ADDENDUM NO. 1

October 26, 2021

CROWN POINT HIGH SCHOOL ADDITIONS AND RENOVATIONS
Crown Point, IN 46307

This Addendum consists of Pages ADD 1-1 through ADD 1-4 and attached Addendum No. 1 from Gibraltar Design dated October 22, 2021 and consisting of 9 pages, Specification Section 11 35 53 - Athletic Equipment, and 131 drawings.

SHEET C-1.0

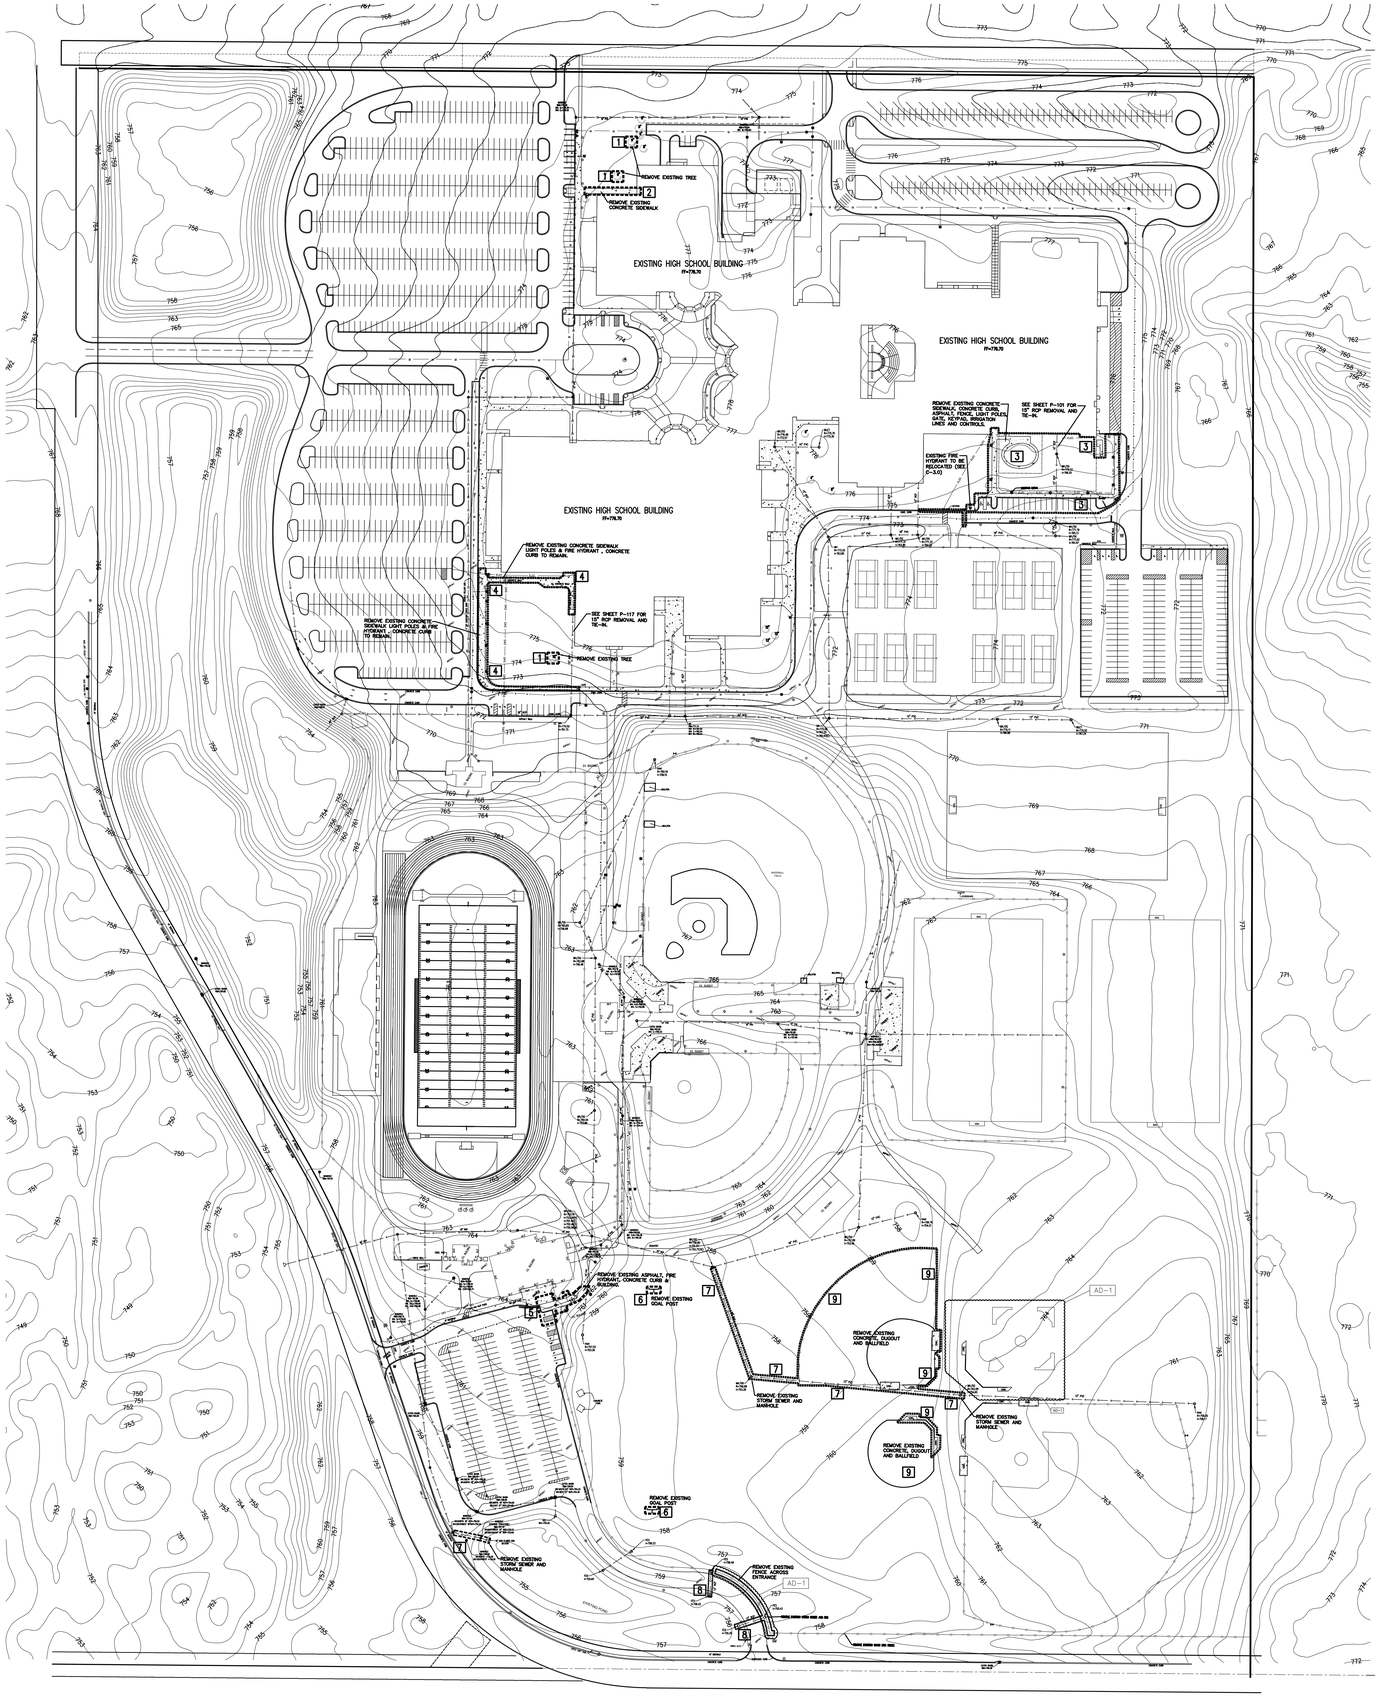
2. **Sheet G-301**
   A. Refer to revised full-size drawing, included in this Addendum, for Added Partition Type "H".
3. **Sheet C-1.0**
   A. Refer to revised full-size drawing, included in this Addendum, for text change for clarification.

SHEET
C-2.0

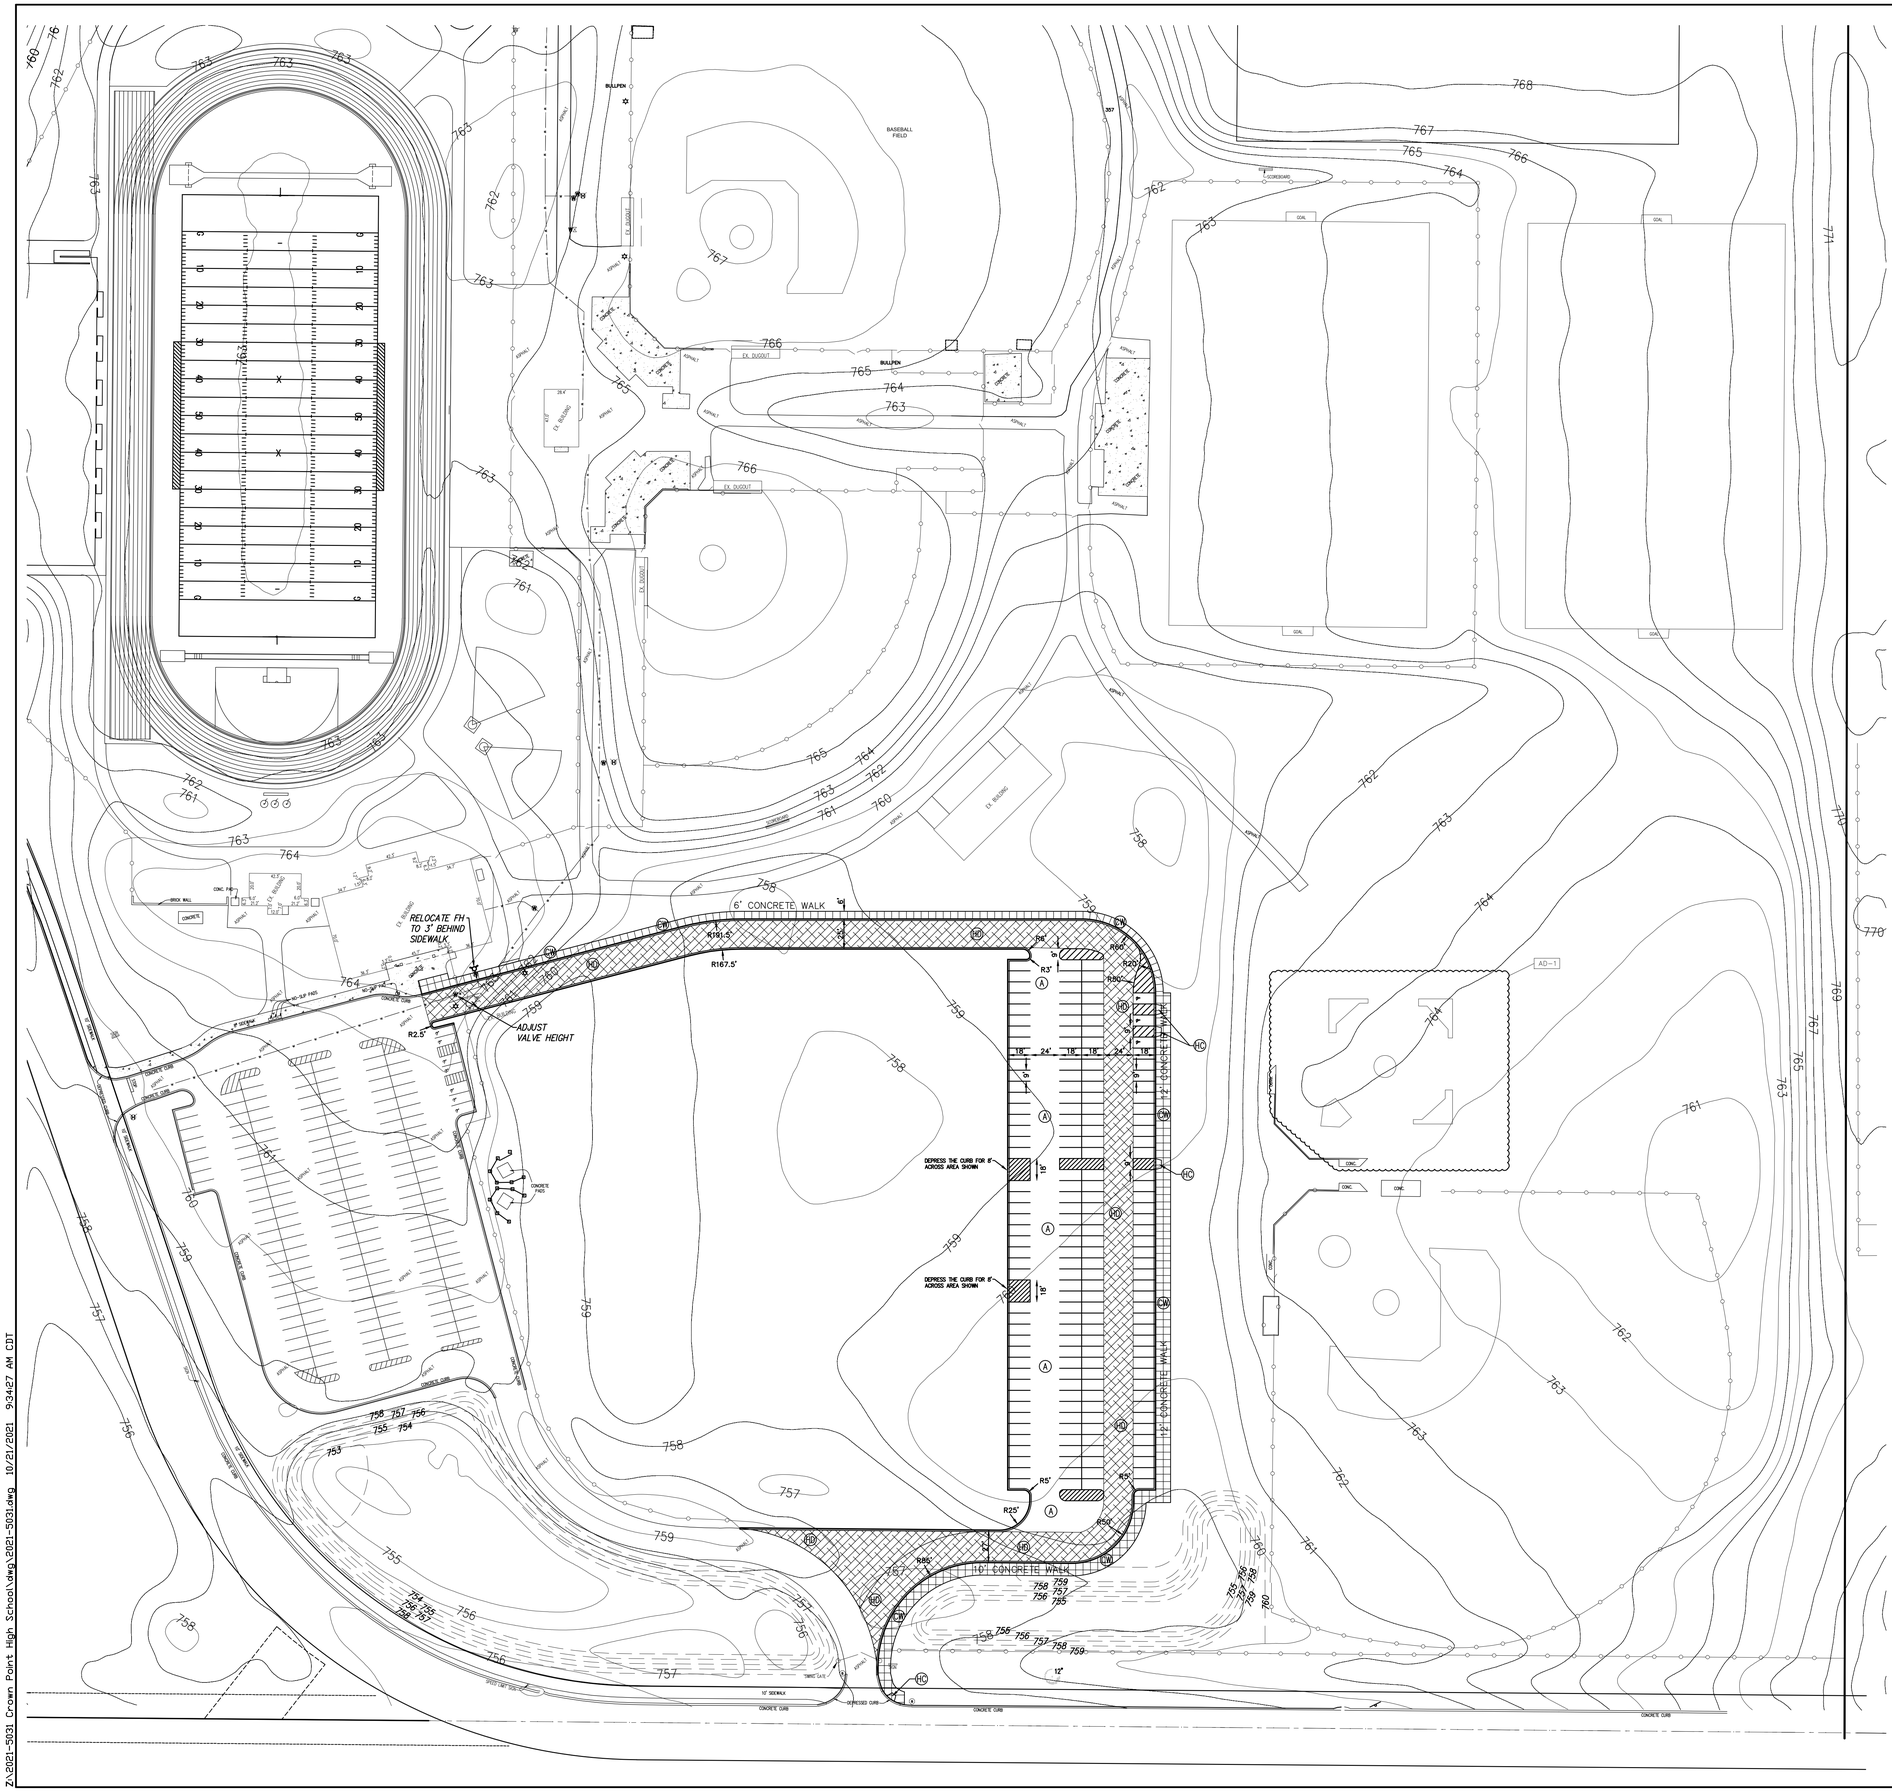
1. Removed Alternate Bid Number 1.
      2. Added Legend information.
6. **Sheet C-2.1**
   A. Refer to revised full-size drawing, included in this Addendum, for removed Alternate Bid Number 1.

SHEET
C-5.0

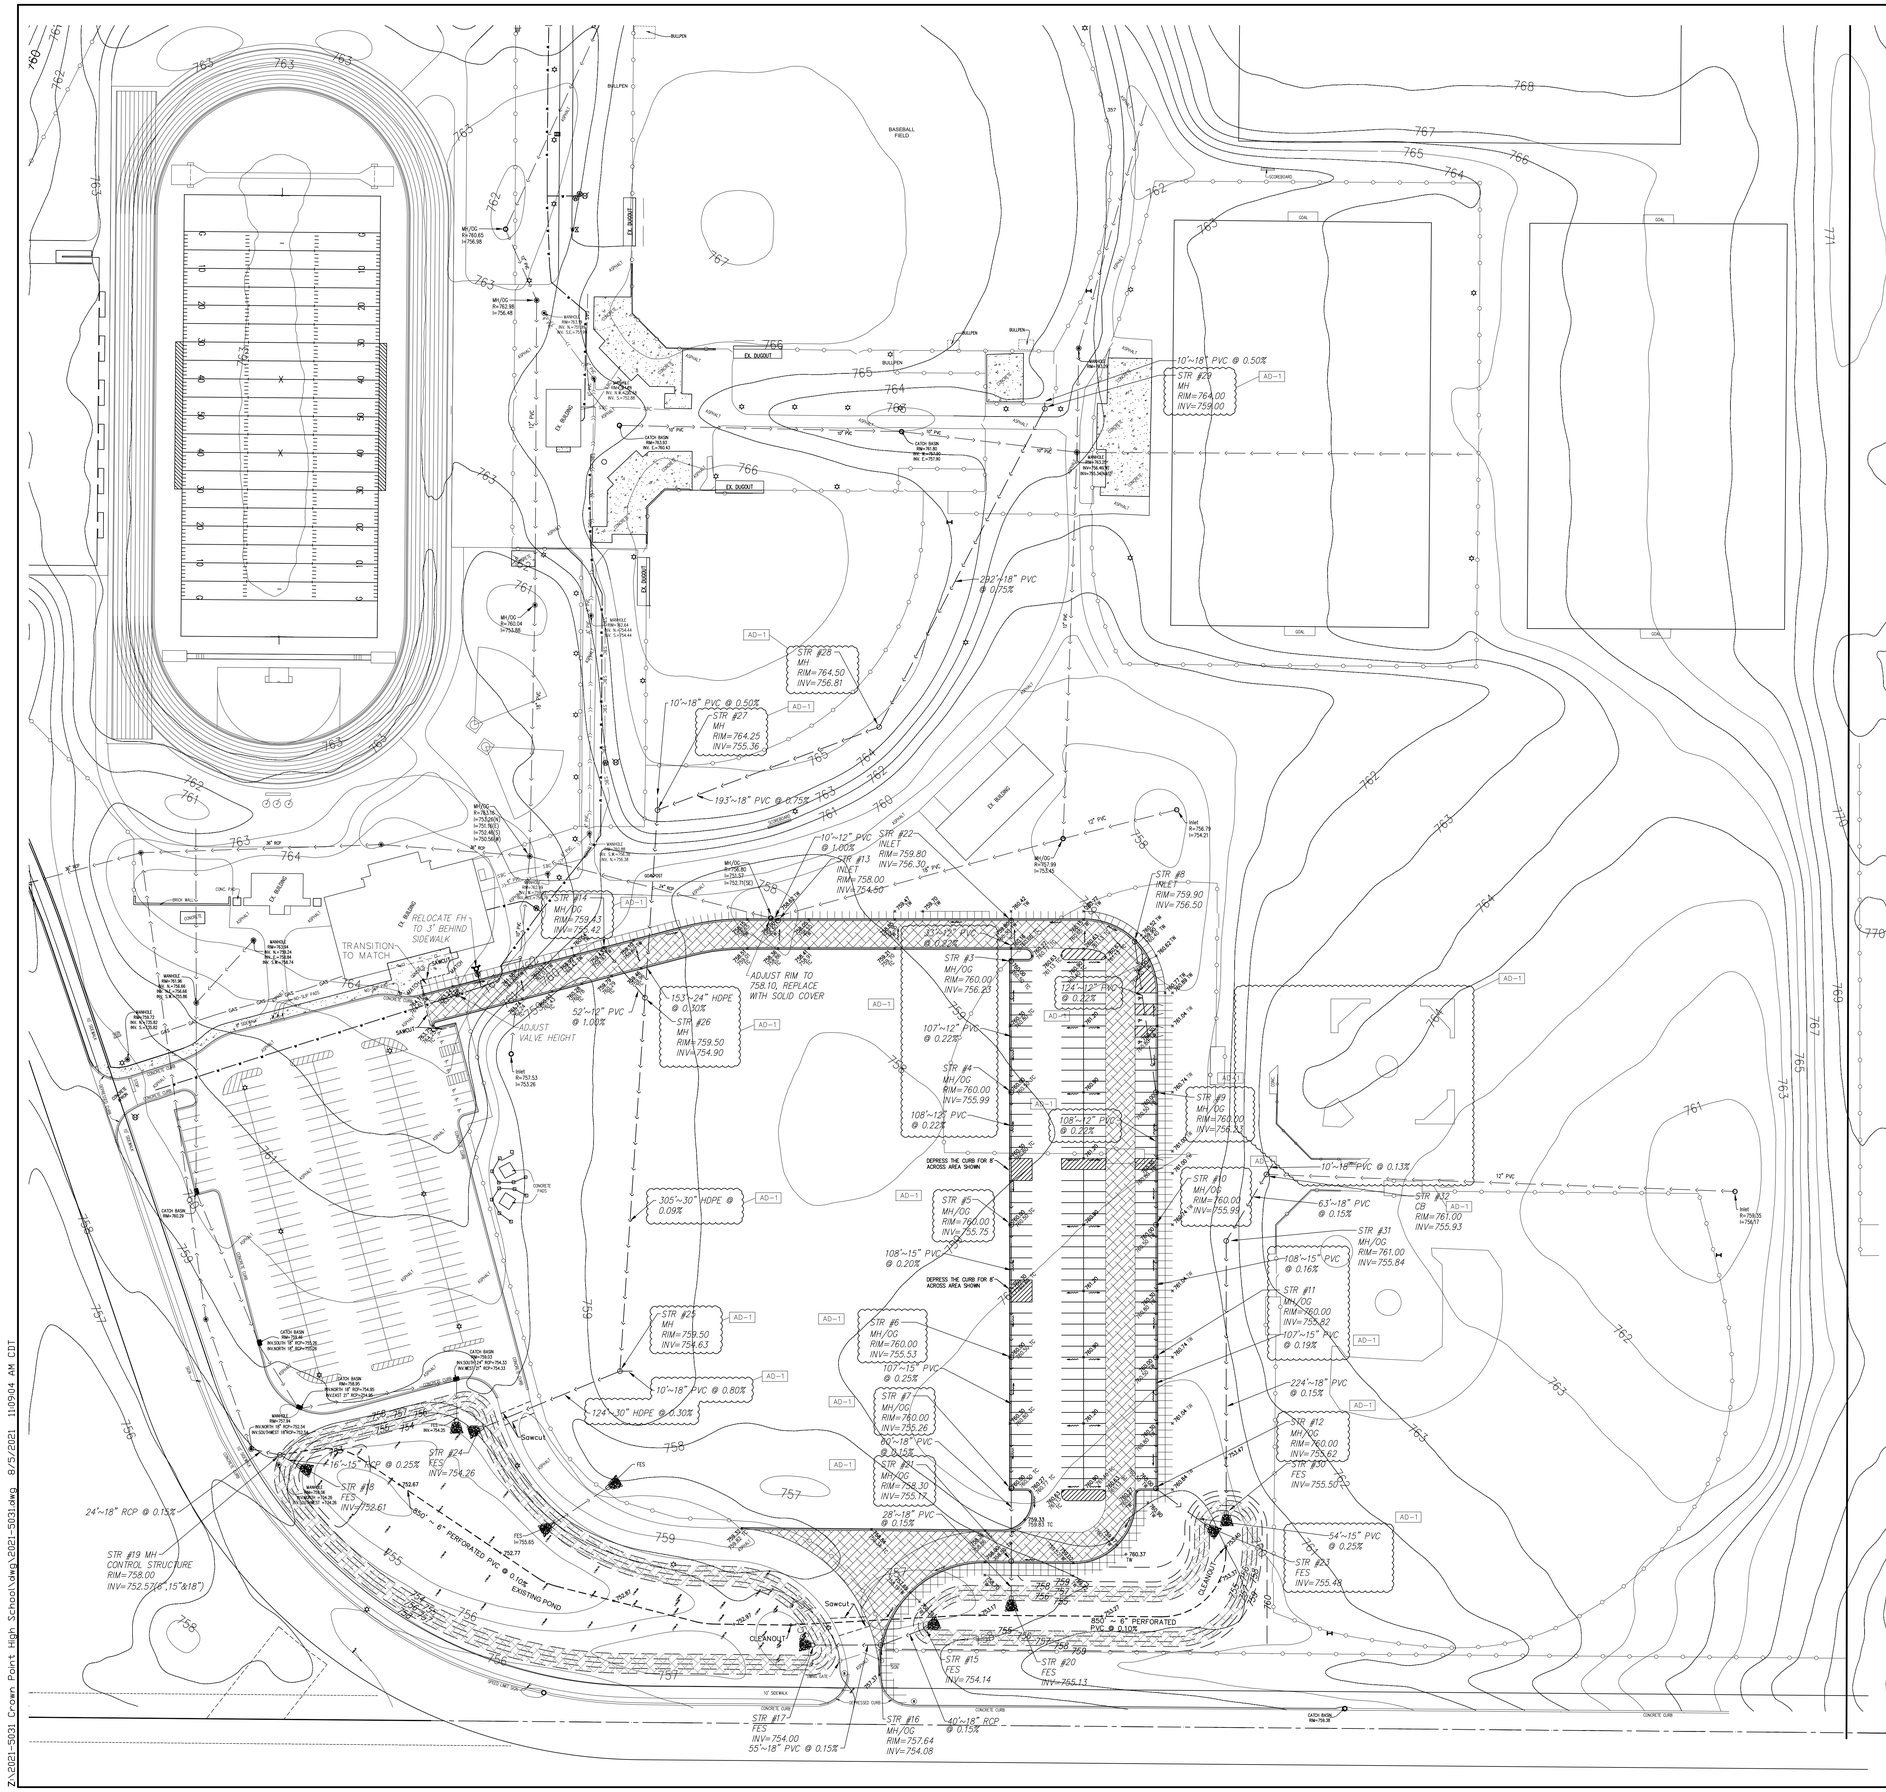
11. **Sheets C-5.0 through C-5.3**
    A. Refer to Four (4) revised full-size drawings, included in this Addendum, for changes to storm sewer type, sizes and slopes, and numbering.
